Re: Inspection Letter: SVF079 Spec Lot 79 Summit – 2323 SW Serena Pl., Lee's Summit, MO

RAFTER TO WALL CONNECTION

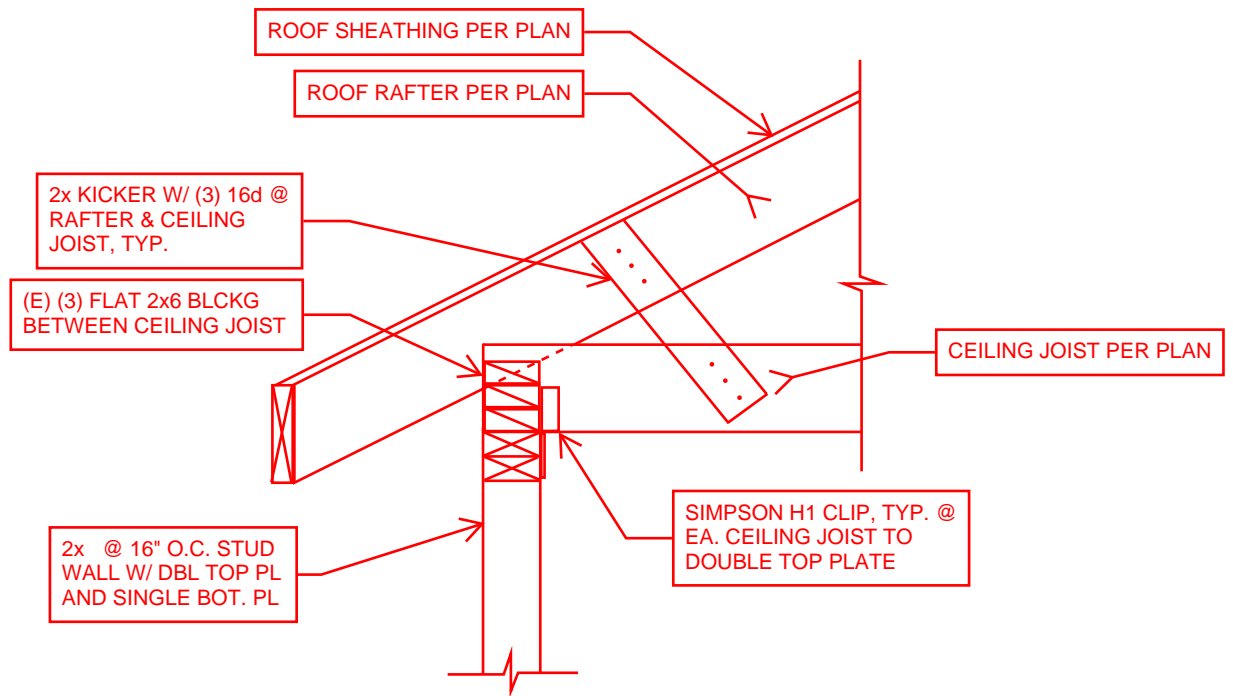
- 1) **Inspection comment:** "Address rafters landing on blocks throughout"

**Vista Structural's response:** *Please see attached detail sketch, 1/SK1. GC to provide 2x kicker w/ (3) 16d to each rafter & ceiling joist. GC to also provide Simpson H1 clip to each ceiling joist to wall double top plate.*
